RESPONSE TO SUBMISSIONS AND PREFERRED PROJECT REPORT

LIGHTHORSE INTERCHANGE BUSINESS HUB (SDD_9667)

10 FEBRUARY 2020
P5115
FINAL
PREPARED FOR WESTERN SYDNEY PARKLANDS TRUST

Figure 2 – Revised Landscape Master Plan

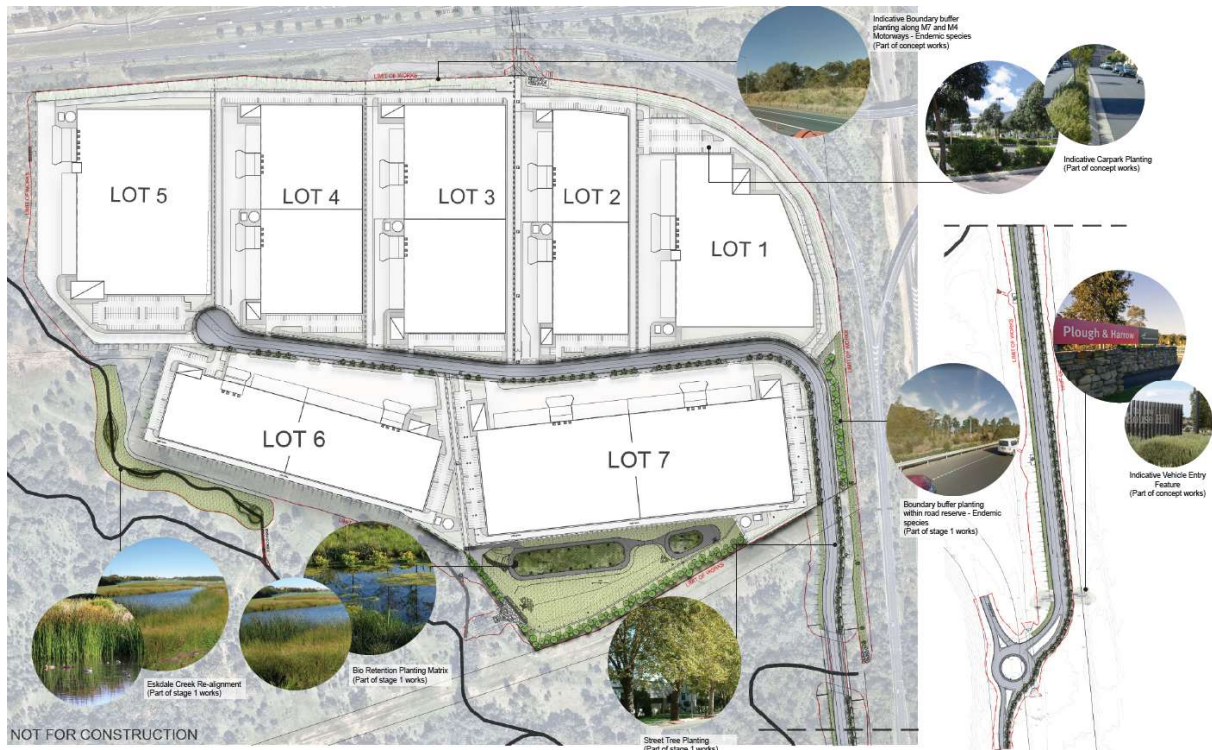
SUBMISSION	RESPONSE
<i>motorway to assist in allowing light and moisture penetration under the two structures.</i>	
<u>Site Landscaping</u>	
<i>EES notes the planting schedule proposes to plant exotic London Plane Trees in the street planting. EES recommends the planting schedule is amended and a diversity of local native provenance species are planted in the street planting and the development lots (rather than plant exotic or non-local natives).</i>	The Planting Schedule has been amended to include a diversity of local native species (refer Appendix C).
<i>The Landscape Plan shows turf is proposed to be planted around the bio-retention basins. It is recommended a diversity of local native of local native provenance species is planted within the basins and surrounding the bio-retention basins (rather than turf) except where access is required for maintenance.</i>	This comment conflicts with Blacktown City Councils Water Sensitive Urban Design (WSUD) Standard Drawings which show that OSD basins, particularly the internal-facing batters of the basins, should be turfed. The areas around the bio-retention basin are currently, and remain, documented as turfed areas in accordance with Blacktown City Councils WSUD Drawings.

- Minor adjustments to the hardstand at lot 6 and 7 to provide additional landscape frontage.
- Landscape Plan and Planting Schedule amended to incorporate local native species and coordination with updated engineer drawings.

Figure 3 – Areas to be managed in accordance with a Vegetation Management Plan

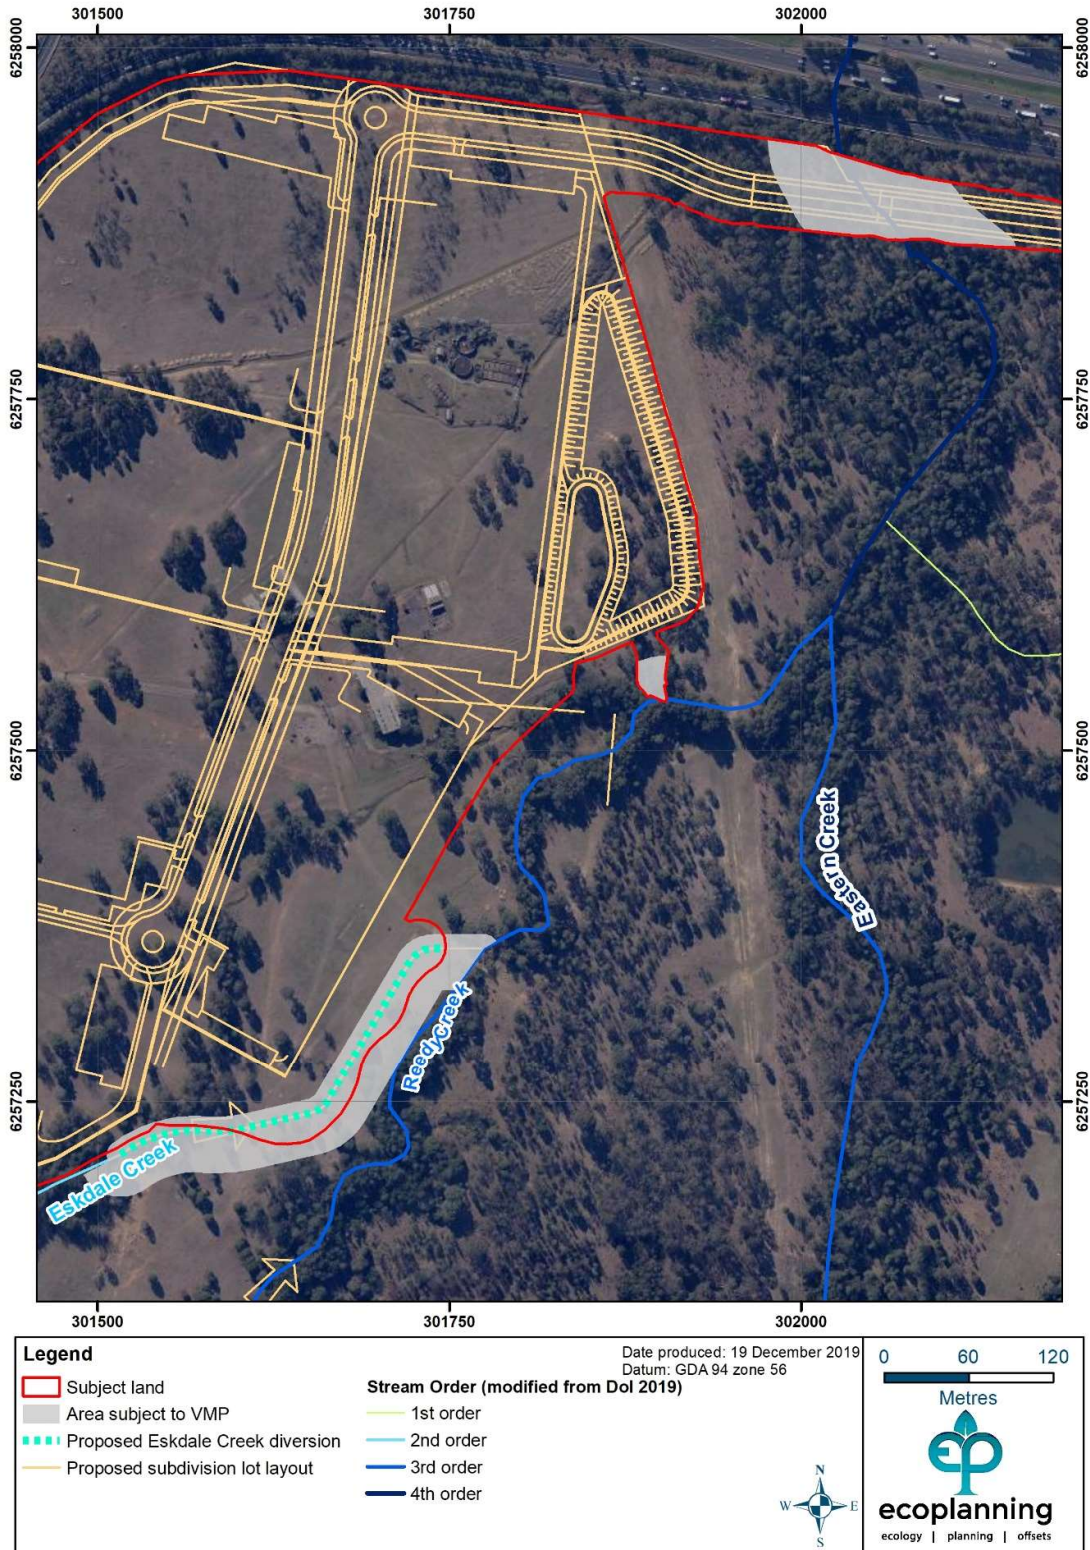
<p><i>A Vegetation Management Plan (VMP) needs to be prepared which provides details on how the corridors are to be protected and restored. If the development is approved a condition of consent should be included which requires a VMP to be prepared and implemented.</i></p>	<p>Agree. A VMP is to be prepared as a condition of consent. This will include appropriate Vegetated Riparian Zones (VRZs) along Eastern Creek, Reedy Creek and Eskdale Creek. The VMP and VRZs will protect and enhance habitat for flora and fauna, including the identified corridor extending along Eastern Creek, while protecting the hydrological processes of these creeks.</p>
<u>Watercourses and Riparian Corridors</u>	
<p><i>EES notes a patch of remnant native vegetation occurs between Reedy Creek and Eastern Creek outside the eastern boundary of the site. EES seeks clarification as to whether this patch of native vegetation is proposed to be protected and managed in perpetuity and included as part of the Bushland Corridor. EES recommends it is protected and included in the Bushland Corridor and if necessary that the bushfire requirements on the site are amended to ensure this vegetation is protected.</i></p>	<p>The area of remnant native vegetation between Reedy Creek and Eastern Creek occurs outside the eastern boundary of the site and does not form part of the current proposal, except for those areas which would be managed as part of the VMP for Vegetated Riparian Zones in accordance with the <i>NSW Water Management Act 2000</i> and as shown in Figure 3.</p> <p>Areas between Reedy Creek and Eastern Creek outside the eastern boundary of the site would be managed in accordance with the broader WSPT Plan of Management and would not form part of the development footprint or VMP associated with the proposed Business Hub.</p>
